CATHOLIC CENTRAL FRONTAGE IMPROVEMENTS JSP 19-48

Public hearing at the request of Catholic Central High School for Planning Commission's approval of Preliminary Site Plan, Wetland Permit, Woodland Permit and Stormwater Management Plan. The subject property is currently zoned R-1 One Family Residential, B-1 Local Business, and I-1, Light Industrial and is located in Section 18, west of Wixom Road and south of Grand River Avenue. The applicant is proposing to enhance the property's Wixom Road frontage, including the two entrances of the property.

PLAN REVIEW CENTER REPORT
Planning Review
CATHOLIC CENTRAL LANDSCAPE/ENTRY
 JSP 19-48
 February 18, 2020

Review Date: February 18, 2020
Review Type: Preliminary/Final Site Plan
Project Name: JSP 19-48 CATHOLIC CENTRAL FRONTAGE
Plan Date: January 22, 2020
Prepared by: Lindsay Bell, Planner
Contact: E-mail: lbell@cityofnovi.org; Phone: (248) 347-0484

Sheet Number: **W101**
 © Grissim-Metz-Andriese Associates, 2020

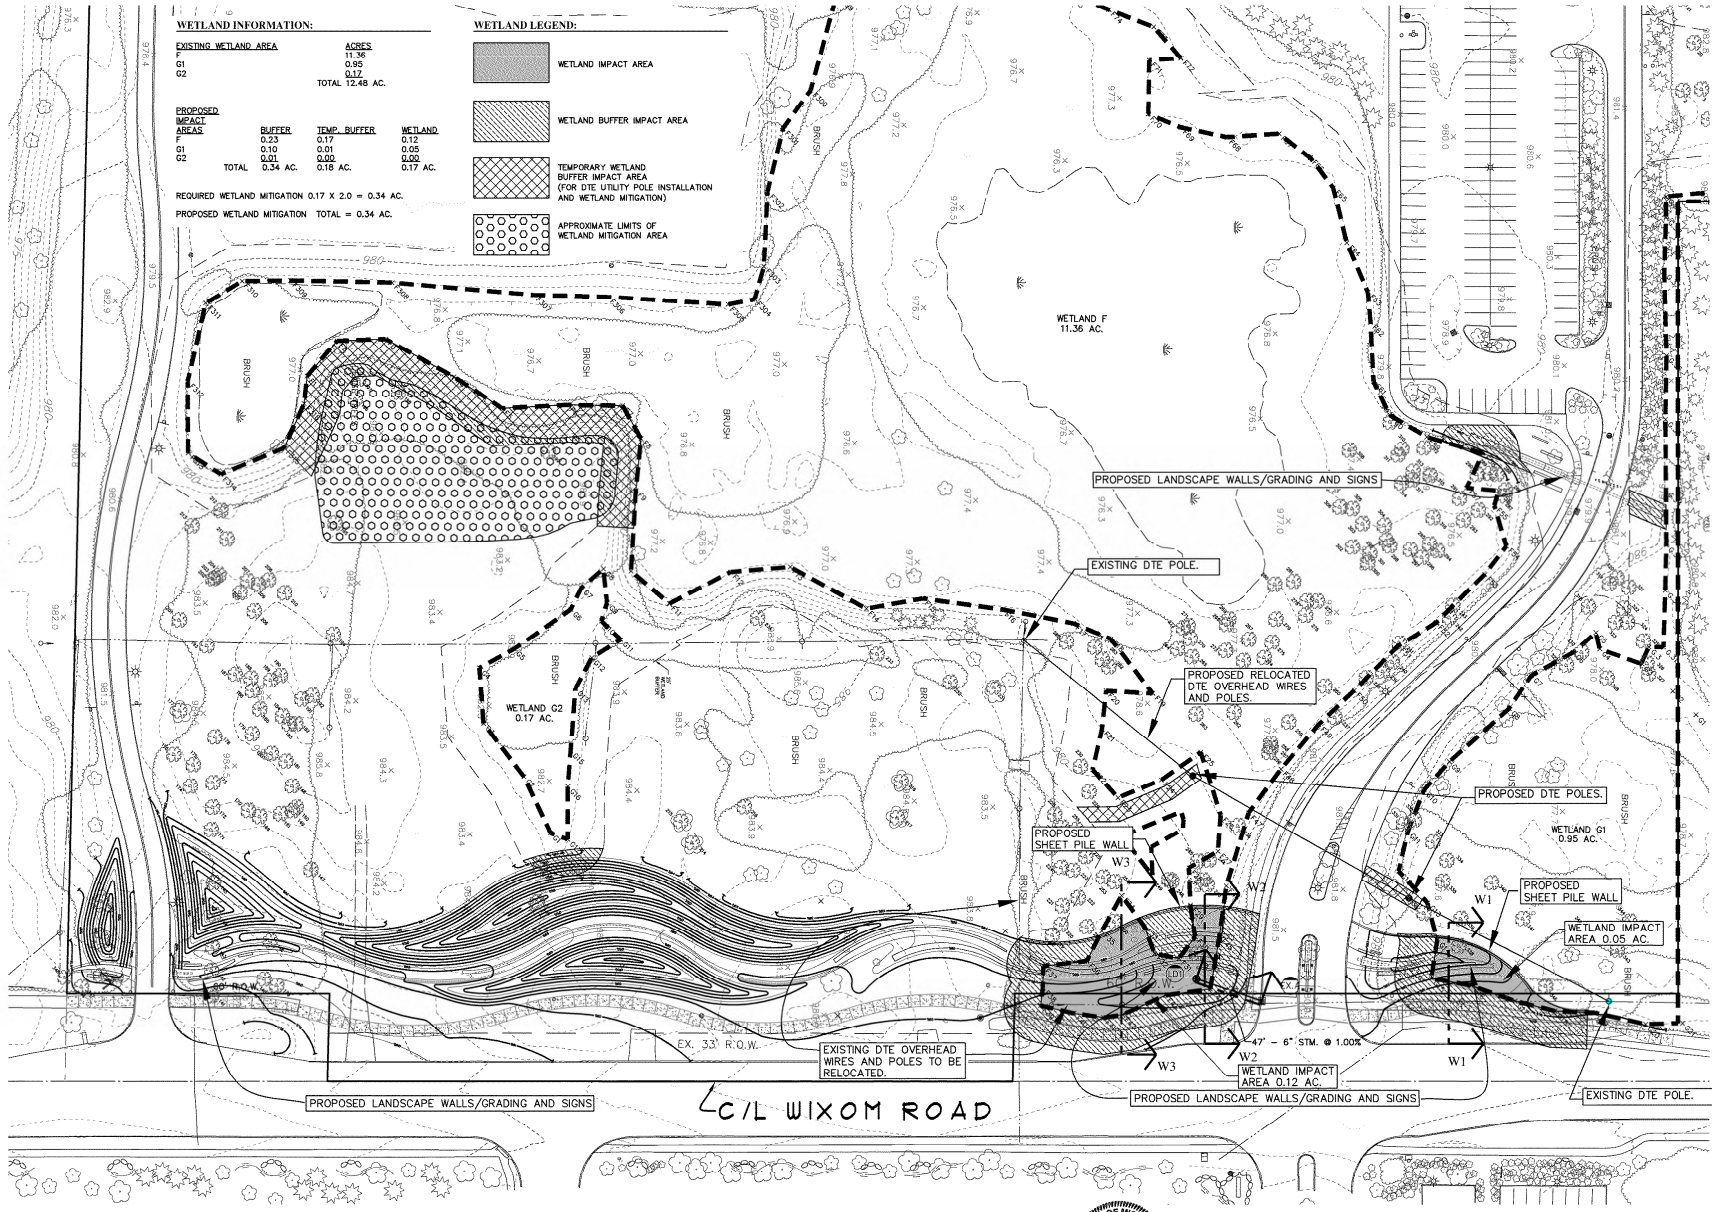
The *Wetland Impact and Mitigation Plan* (Sheet W101) indicates the proposed impacts to on-site wetlands and 25-foot wetland setbacks. The proposed development appears to require the filling of some areas of existing wetland and 25-foot wetland setback. The current Plan indicates the following proposed impacts for the construction of the proposed landscape walls and associated grading:

Sheet W101 (*Wetland Impact and Mitigation Plan*) outlines the currently proposed wetland mitigation area. The Plan proposes one (1) area of wetland mitigation totaling 0.34-acre (0.17-acre impact x 2.0). The proposed area of wetland mitigation is located just north of the south entrance drive and is proposed adjacent to a previously constructed area of mitigated wetland. The Plan is proposing to meet the City's (and EGLE's) mitigation ratio of 2.0-to-1 for impacts to forested wetland areas.

1. See enclosed MDEGLE Permit Application Submittal of January 22, 2020.
2. Retaining walls are proposed to minimize impacts to wetlands and wetland setbacks.
3. On-site acreages for the 25-foot wetland setback areas of the directly affected wetlands will be indicated.
4. Volumes (cubic yards) of proposed wetland impacts will be added.
5. See enclosed MDEGLE Permit Application Submittal of January 22, 2020.
6. See Sheet WM102 for Upland Buffer Seed Mix.
7. Performance standards and annual monitoring methodology will be added to the wetland mitigation plans.
8. A conservation easement over the wetland mitigation area will be granted to the MDEGLE.

Figure 1. City of Novi Regulated Wetland & Woodland Map (approximate project areas are shown in red). Regulated Woodland areas are shown in green and Regulated Wetland areas are shown in blue.

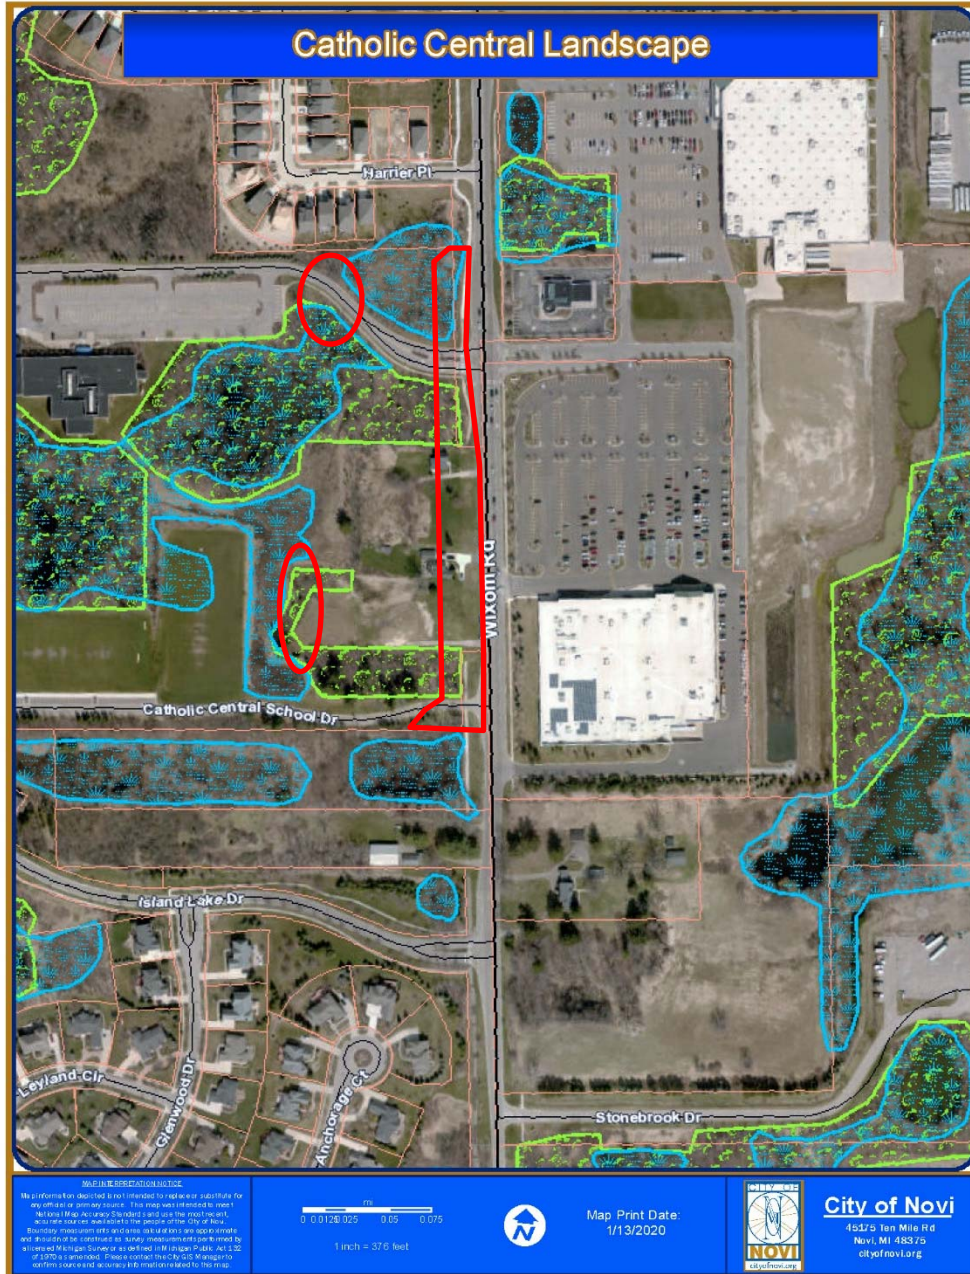
ECT's in-office review of available materials included the City of Novi Regulated Wetland/Watercourse and Regulated Woodlands maps (see Figure 1, attached), USGS topographic quadrangle map, NRCS soils map, USFWS National Wetland Inventory map, and historical aerial photographs. The City of Novi Regulated Wetlands Map indicates existing wetland area north of the main/northern entrance drive to the campus, south of the southern entrance drive and near the area of proposed wetland mitigation.
